| 10/9/2008 | ECN-98691 | |

DESCRIPTION: MODIFIED ERM8 ASSEMBLY
 DWG. NO. ASP-133811-02
 BY: D UNDERWOOD 7/10/07 SHEET 1 OF 2

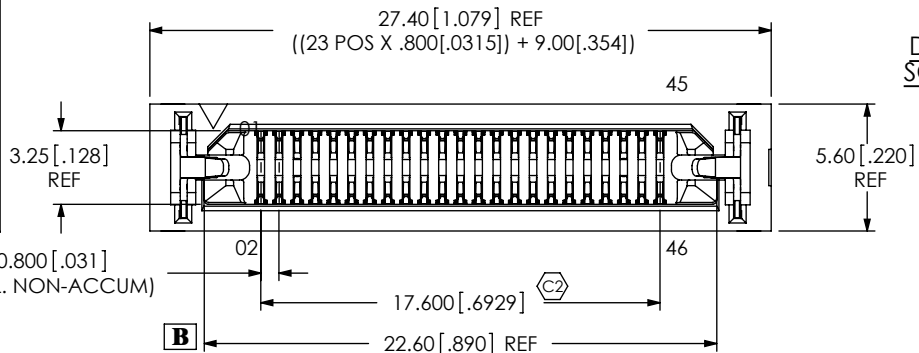
SHT 1, BOM CHG WT-29-01-F TO WT-29-07-F, TOP VIEW; DEL C13 DIM 22.50, ADD DIM 22.60 REF; FRONT VIEW; DEL DIM 22.60 REF, ADD DIM C13 22.50.
